HOSKINSON ADDITION

WICHITA, SEDGWICK COUNTY, KANSAS

Re: S/D 94-39 HOSKINSON ADDITION - (Final Plat)

STAFF REPORT

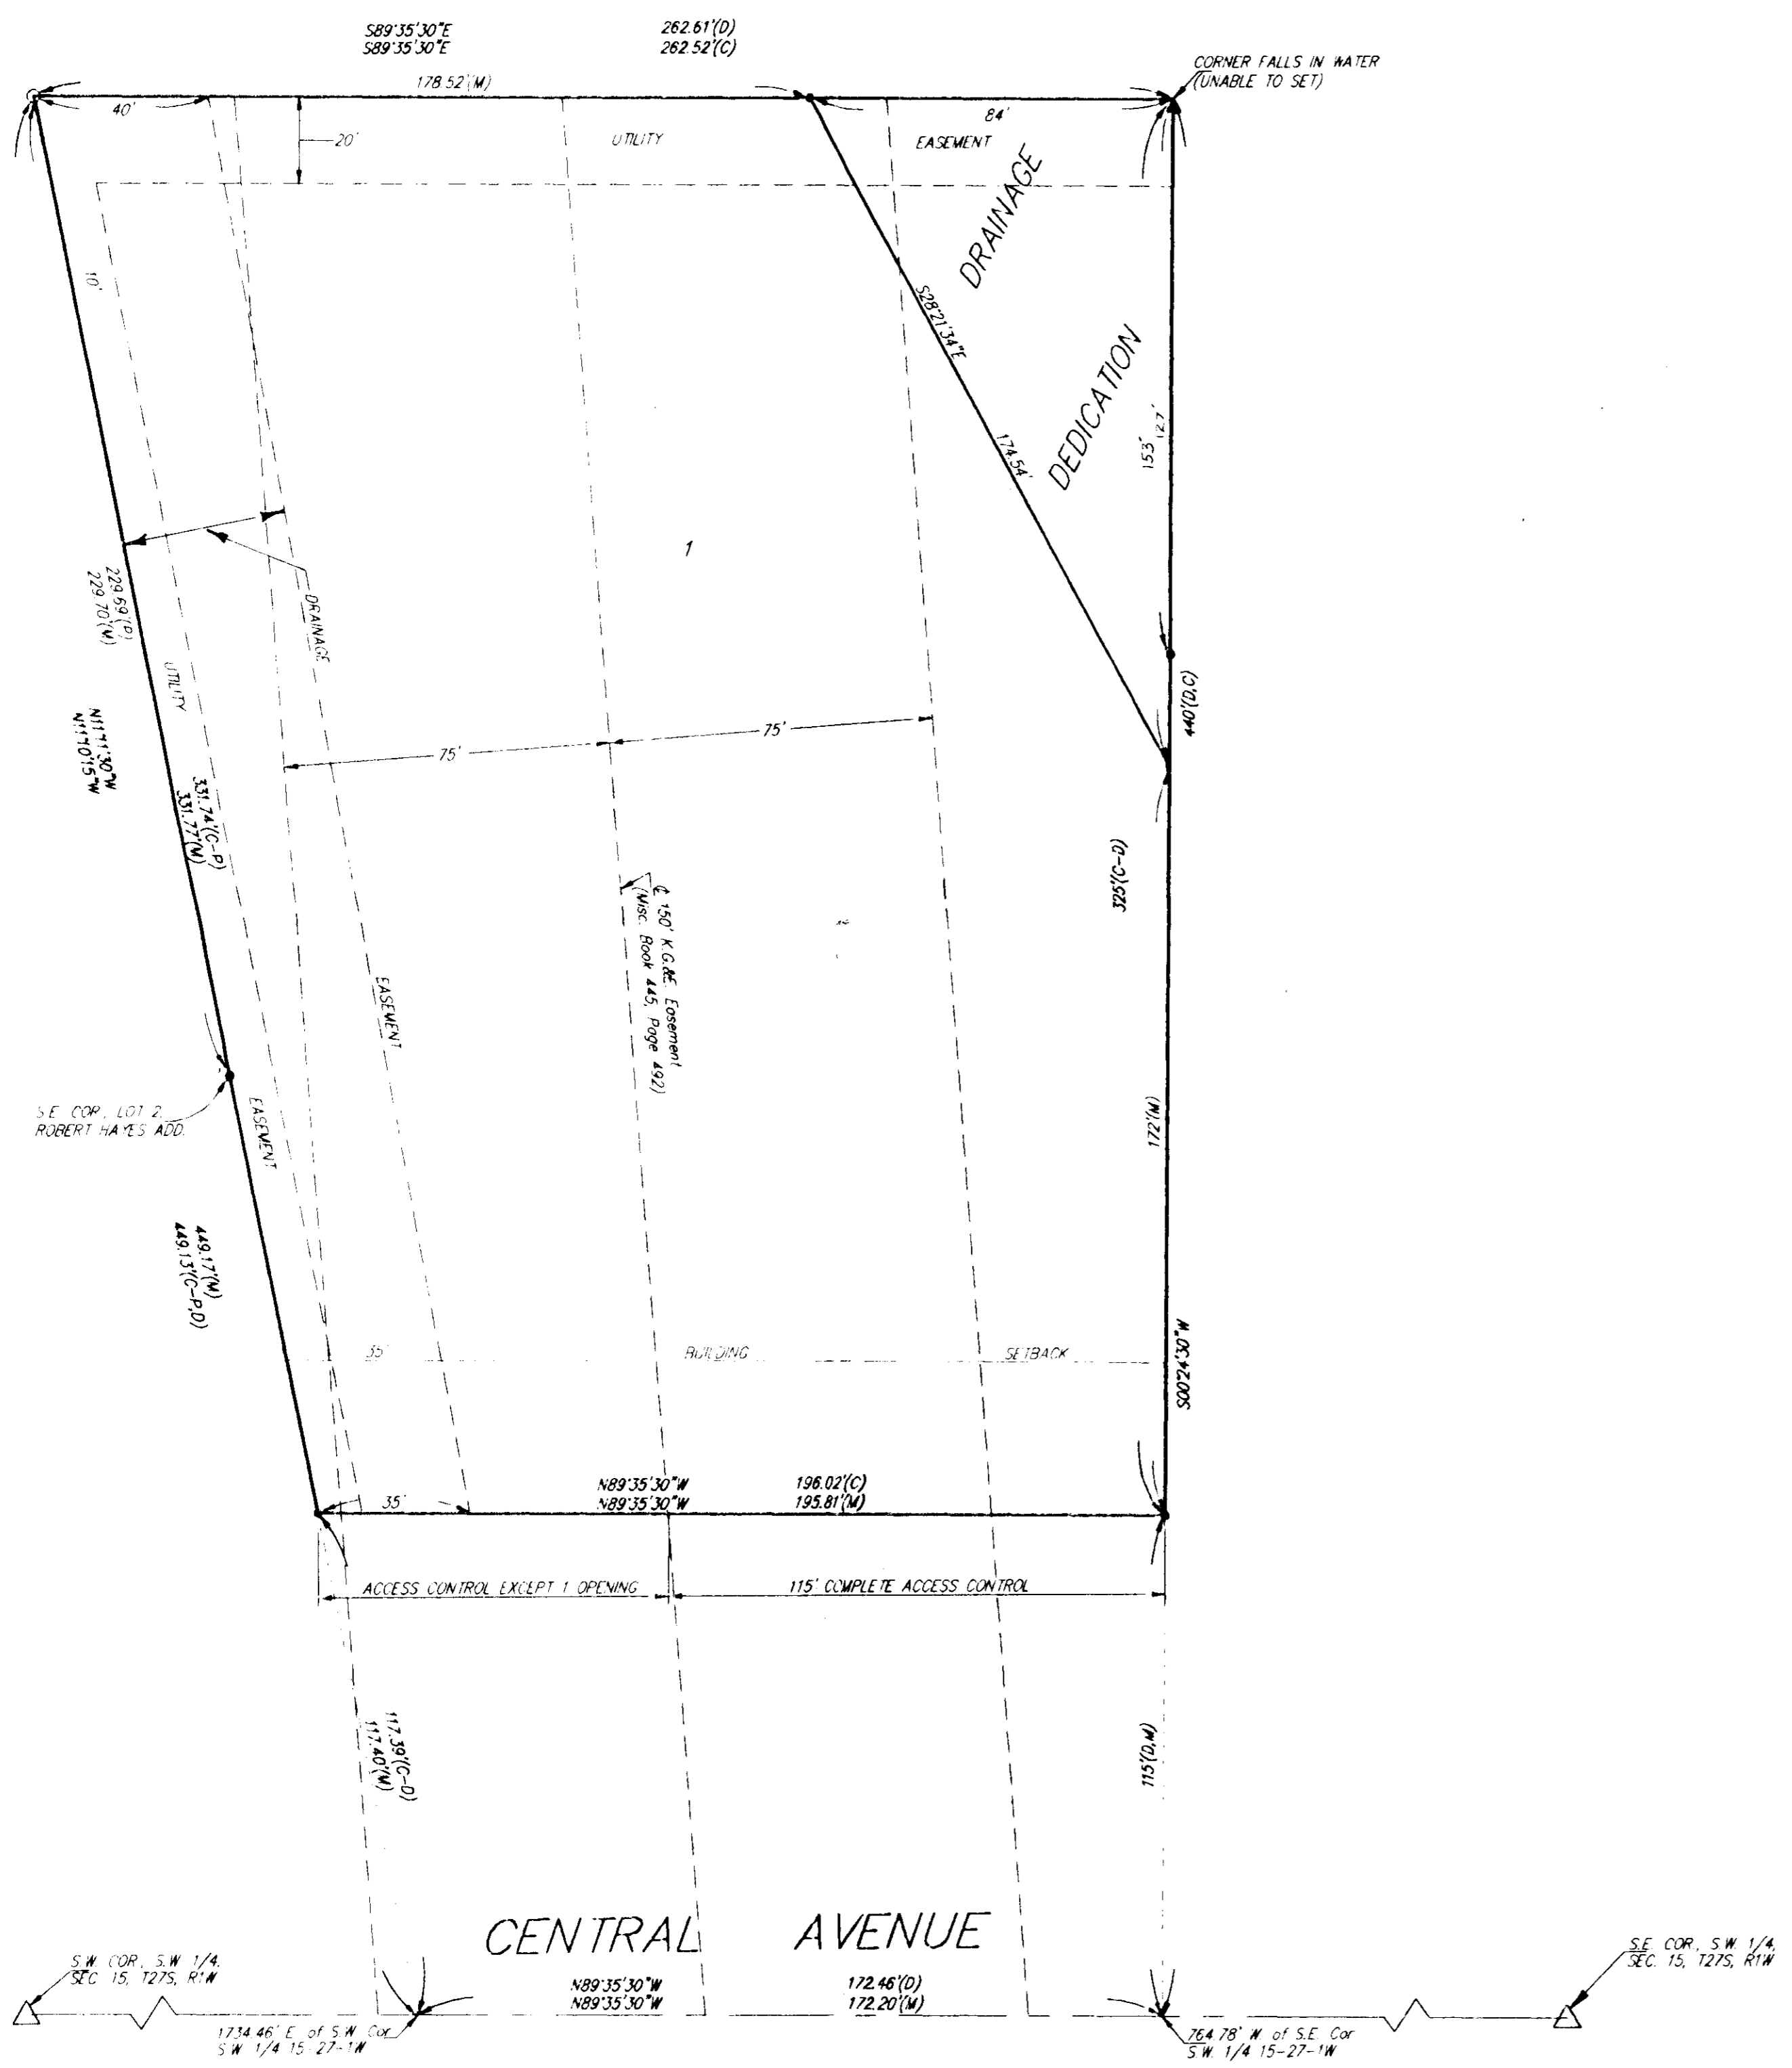
- D. Also as indicated by Traffic Engineering, access control shall be limited to one opening, located toward the west line of this site. Complete access control shall be shown to Central except for the area of this entrance.

- I. The final plat tracing shall label the 35-foot building setback to Central.
- J. Based on the platting binder, numerous easements created by separate instrument are shown as possibly involving this site. The applicants shall submit a letter and/or marked copy of this plat explaining if these easements are being replatted, vacated, or are not actually located within this Addition.

- K. As indicated by City Engineering, the final plat tracing needs to indicate more of a drainage easement at this site's Northeast corner, that is, the replatting of this site shall not vacate the drainage area corresponding to the bank in this area.

- L. As offered by the applicant, a public access easement needs to be provided in the area of this plat's east line. Such easement may be granted on the final plat tracing or if granted by separate instrument shown on the plat tracing while referencing that the easement has been "granted by separate instrument".
